**Pacific Gas and
Electric Company**

July 31, 2017

Subject: Response to DTSC's Geological Services Unit April 6, 2017 Memorandum titled *Proposal for Alternative Groundwater Sampling Trial, Pacific Gas and Electric, Topock Compressor Station*

FIGURE B2-2
SUMMARY OF HYDROGEOLOGIC LOGGING
FOR CW2 COMPLIANCE WELLS
IM-3 GROUNDWATER INVESTIGATION
PG&E TOPOCK COMPRESSOR STATION
NEEDLES, CALIFORNIA

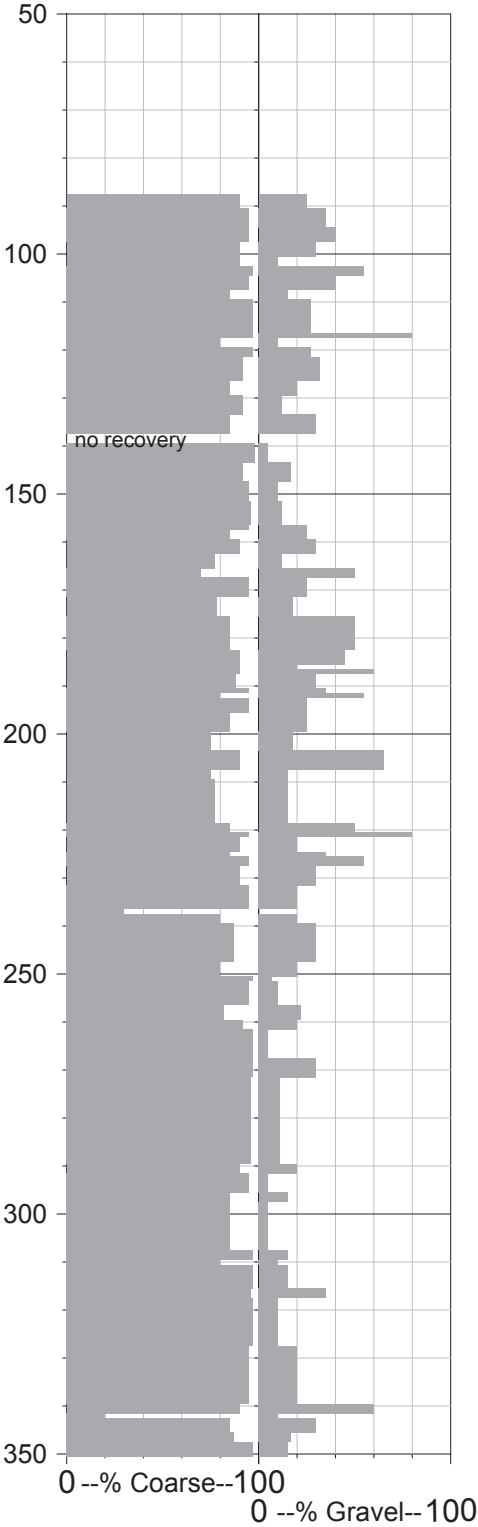
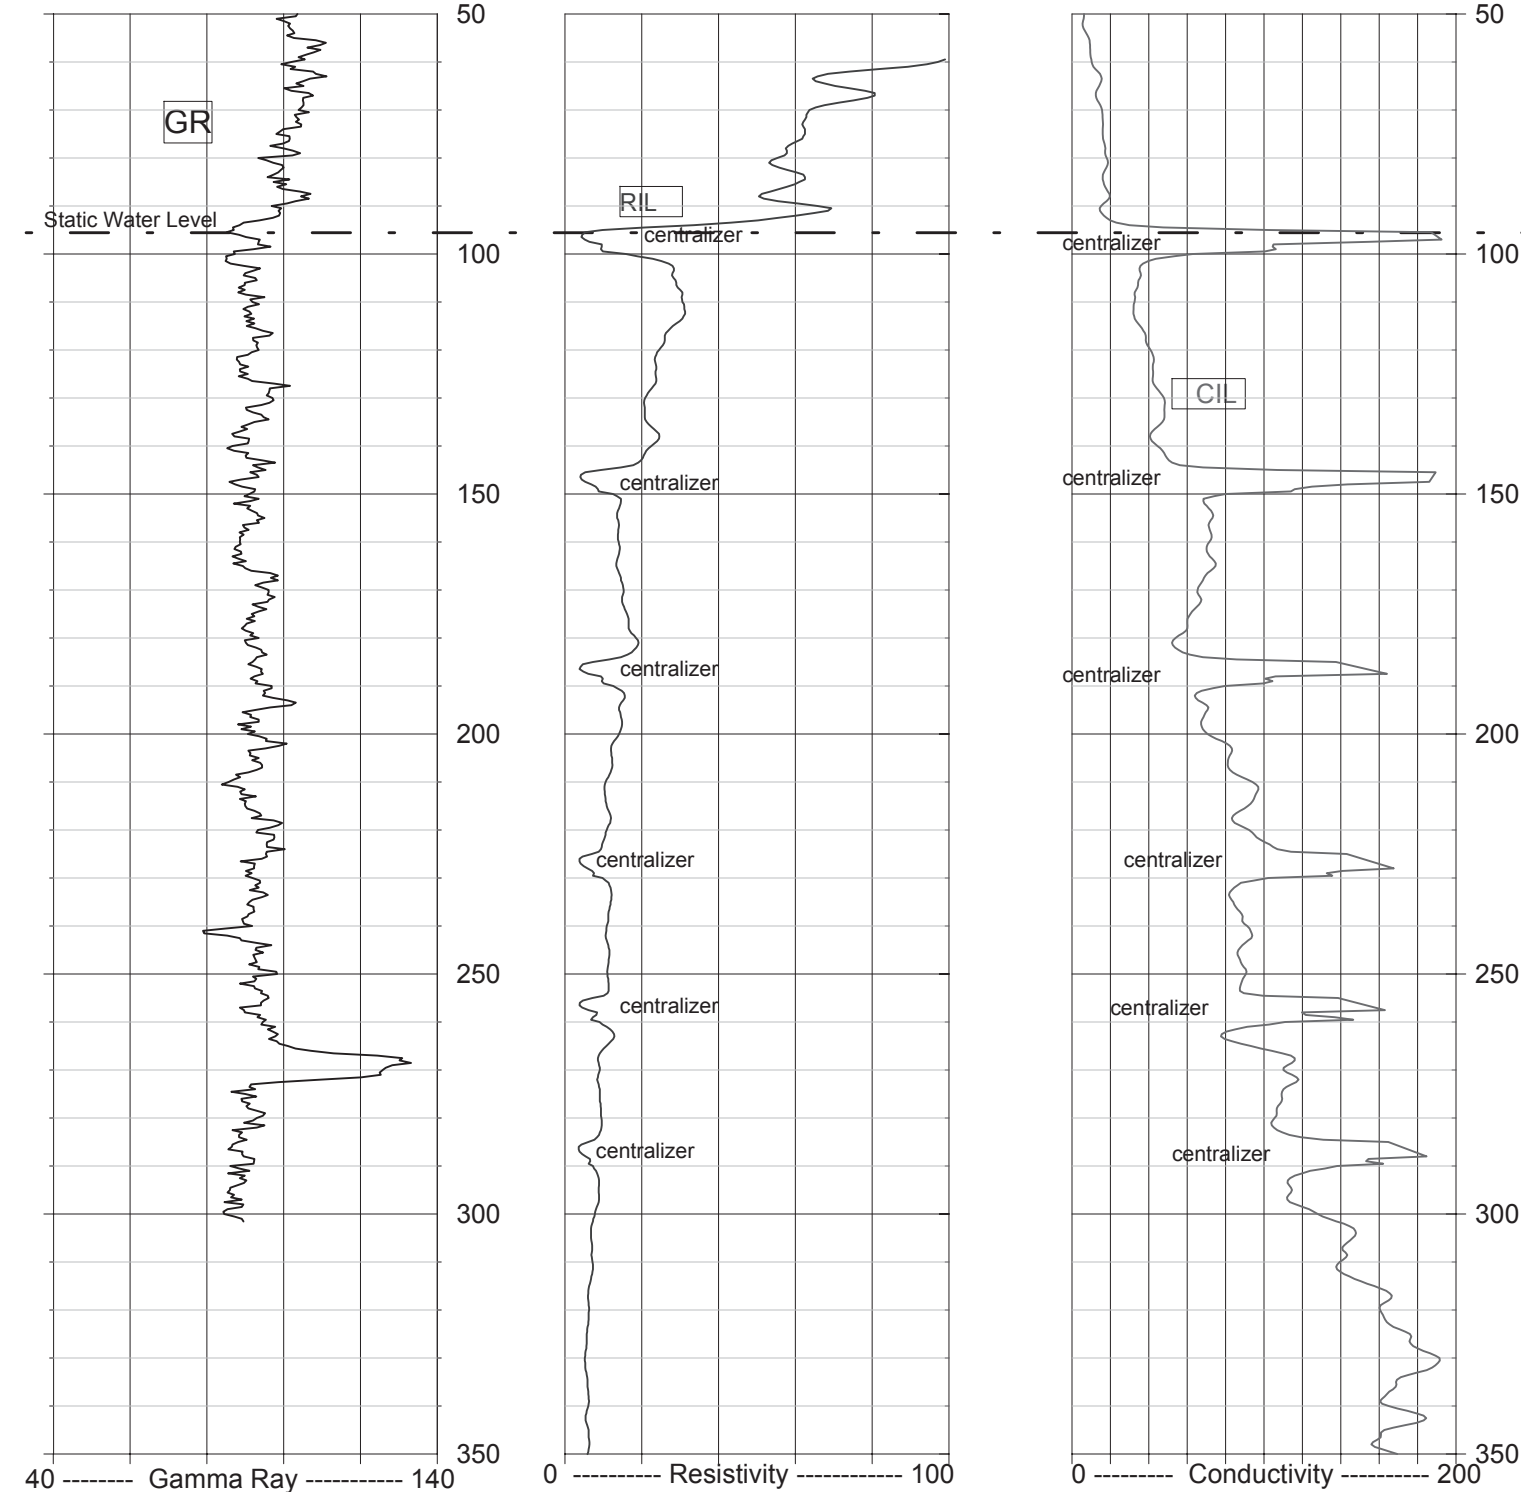
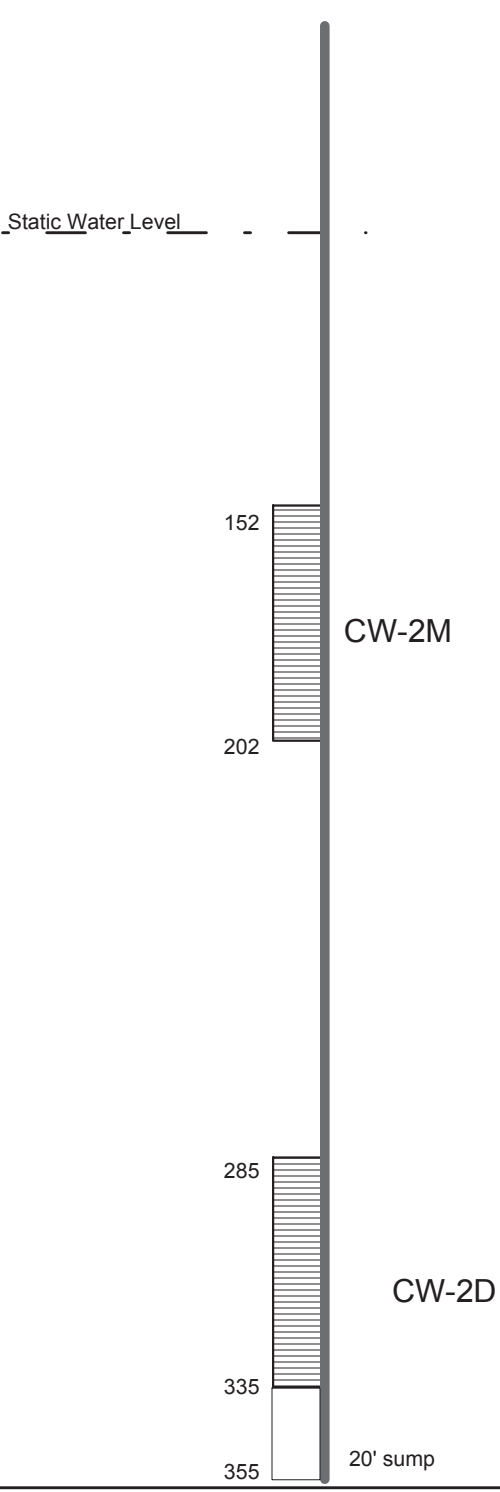
MW-60-125, MW-74-240, OW-3S; OW-1S, OW-1M, OW-1D, OW-2S, OW-2M, OW-2D, and OW-5D	Change to MD with pump at mid- screen	MD approved with SC profile approved in these wells with 30-foot or shorter screens.	Accept – begin MD sampling in Q4 2017 and SC profile the deep screen “D” wells, with request for deviation below. <u>Request for deviations from April 2017 Letter:</u> 1) No SC profile for shallow alluvial wells screened above bedrock.
OW-5S, OW-5M, CW-1M, CW-1D, CD-2M, CW-2D, CW-3M, CW-3D, CW-4M, CW-4D	MD Trial, midscreen	MD Trial approved with SC profile and flow testing to select MD sampling depths in these wells with 40 to 50-foot screens	2) logs (attached) were reviewed to select MD sampling depths (feet bgs) for Trial in longer screen wells, because flow testing not practical in 2-inch wells: - OW-5S 107 feet, OW-5M 240 feet - CW-1M 175 feet, CW-1D 267 feet - CW-2M 177 feet, CW-2D 317 feet - CW-3M 197 feet, CW-3D 297 feet - CW-4M 150 feet, CW-4D 280 feet

MW-58BR and MW-64BR Construction History

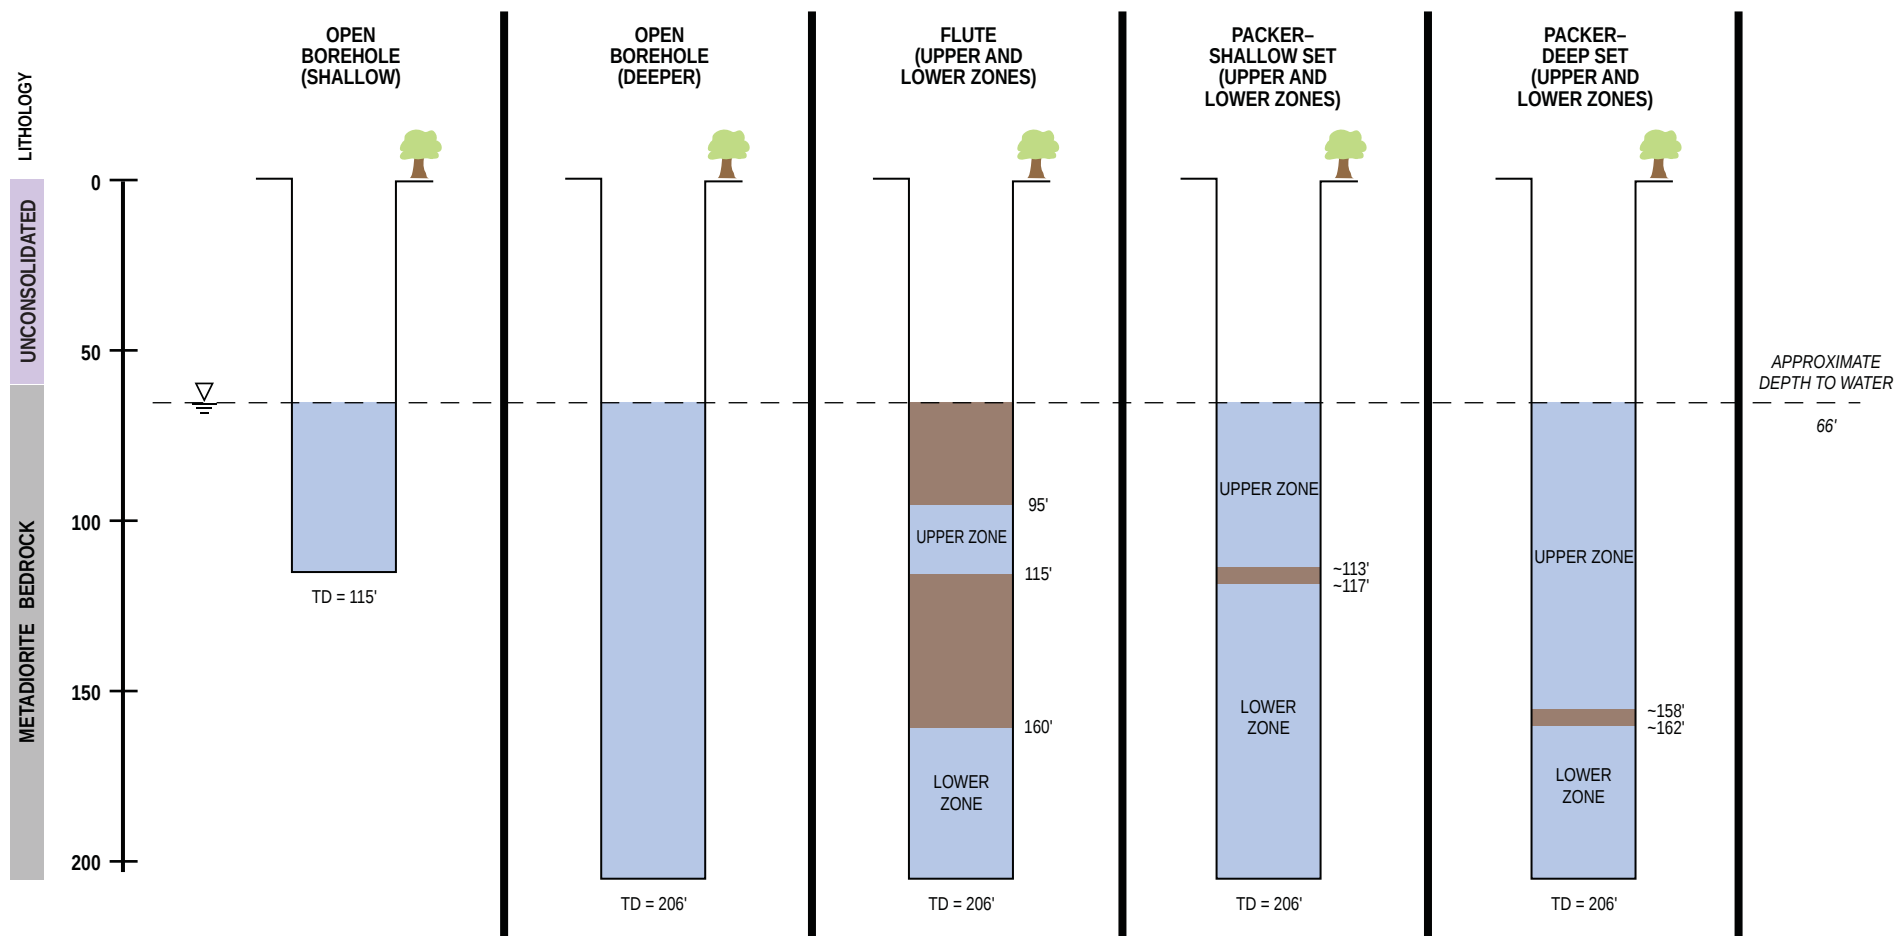
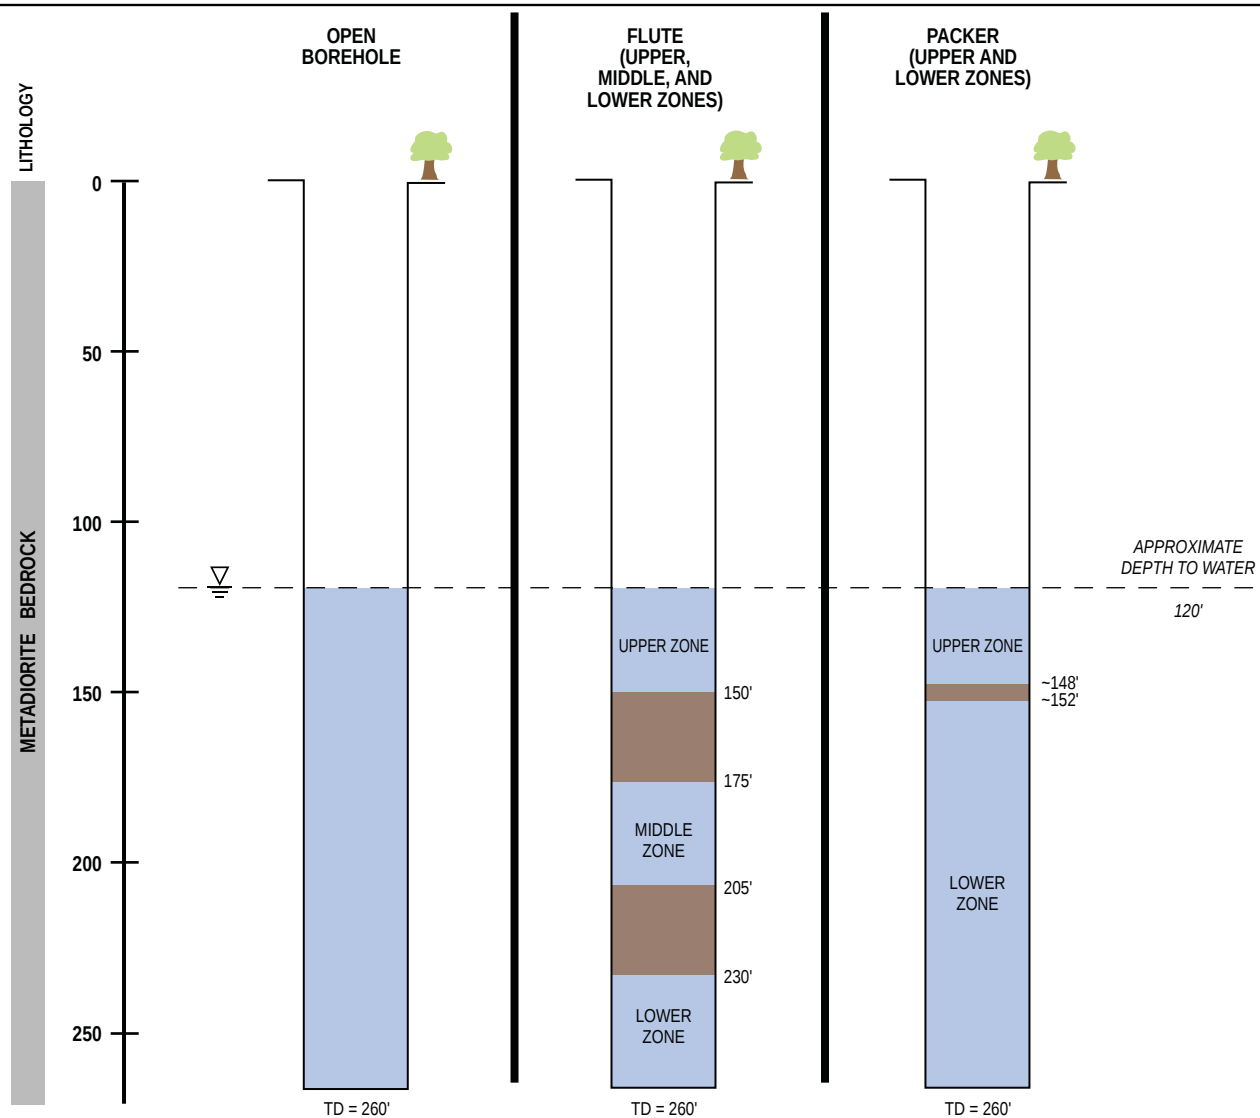
MW-57-070	Change to MD with pump at mid- screen	MD approved with SC profile	Accept - Collect SC pH profiles; begin MD sampling in Q4 2017.
MW-57-185	MD Trial with pump at 171 feet	Trial of MD at 2 depths 150 & 171 feet vs. 3V purge, SC profile	Accept - Collect SC profile and begin sampling trial in Q4 2017.
MW-58BR	Continue current MD sampling purge approach, with pump at 190 feet	Reconstruct well with screens corresponding to former packer placement in bedrock open bore, add flood protection	Accept – Evaluate and add flood protection, with a request for deviation below. <u>Request for deviation from April 2017 Letter: Continue current sampling.</u> Remedy use is planned with current sampling approach after several multilevel configurations in past.
MW-60BR-245	MD Trial, with pump at 180 feet	Trial of MD at 2 depths 175 & 238 feet vs. 3V purge, SC profile	Accept - Collect SC profile and begin sampling trial in Q4 2017.
